SUBSURFACE WASTEWATER DISPOSAL SYSTEM APPLICATION

Town Or Plantation	Augusta
Street Subdivision Lot #	Cross Hill Road

AUGUSTA PERMIT # 1,198 TOWN COPY

See back side revised 10/17/88

SUBSURFACE WASTEWATER DISPOSAL PLAN

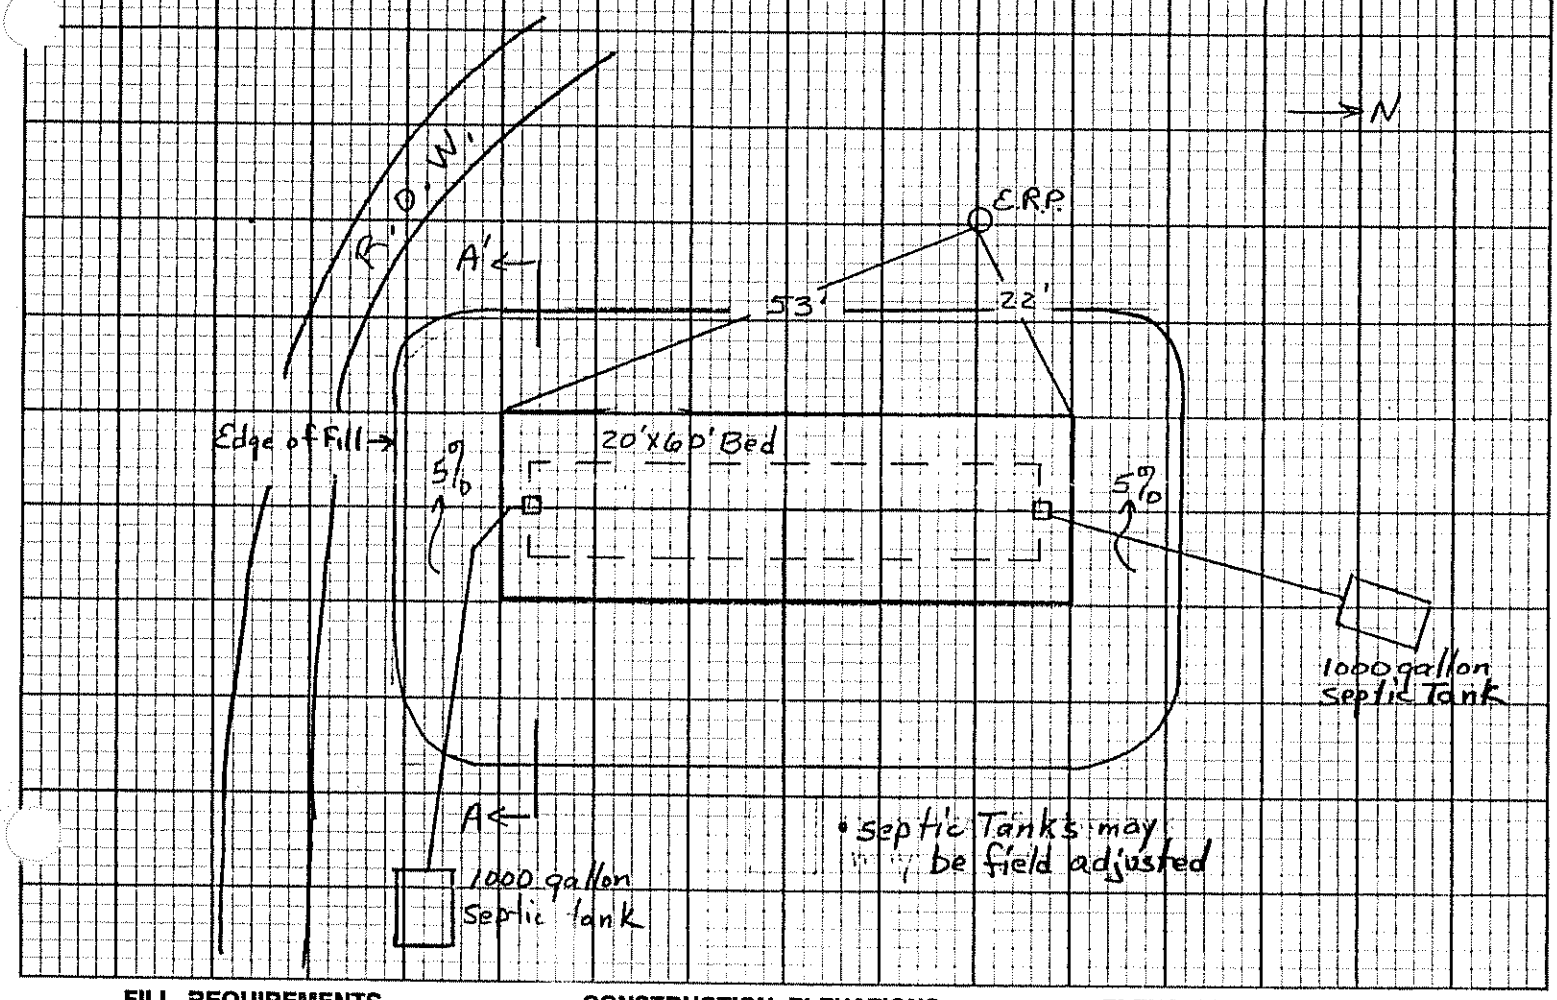
DISPOSAL SYSTEM TO SERVE:
1. ☐ SINGLE FAMILY DWELLING
2. ☐ MODULAR OR MOBILE HOME
3. ☐ MULTIPLE FAMILY DWELLING
4. ☒ OTHER 2 Mobile Homes (SPECIFY)

10-17-88 Site visit ok for 1500 gal tank to serve both - Bart W.P.B.

SIZE: 2 — 1000 GALS.

CRITERIA USED FOR DESIGN FLOW (BEDROOMS, SEATING, EMPLOYEES, WATER RECORDS, ETC.)
2-2 bedroom
2 mobile Homes
@ 180gpd each

DESIGN FLOW: 360 (GALLONS/DAY)
